**Reference: 669 High Street - Major Site Plan Review#3  
Candia Tax Map 405 Lot 48 – Candia Planning Board Case#24-002**

**RE: Response Letter 2  
Beaver Meadows Duplex Development  
669 High Street Candia, NH  
Map 405, Lot 48  
JBE Project No. 22201**

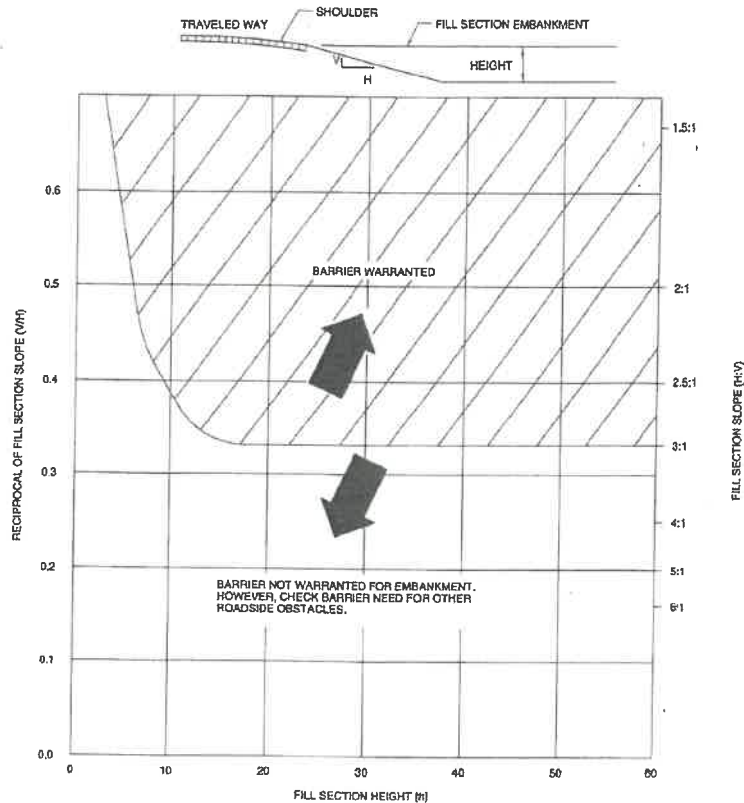
55. *It appears that, based on the proposed grading, that guardrail is required from STA 1+60 to STA 2+70 on the right side of the road.*

*Comment not addressed; guardrail is required where side slopes exceed 4-feet horizontal and 1-foot vertical for vertical drops greater than 5-feet as specified in Regulation Section 8.17.*

**RESPONSE:** The only location with a drop of greater than 5 feet at a slope of greater than 4:1 adjacent to the pavement is around the cul-de-sac island where the detention pond is proposed with a 3:1 slope. However, we are requesting a waiver for providing guardrail in this area. Guardrail is not typically warranted for a 3:1 slope for fill heights under 15 feet. See below AASHTO guidance diagram.
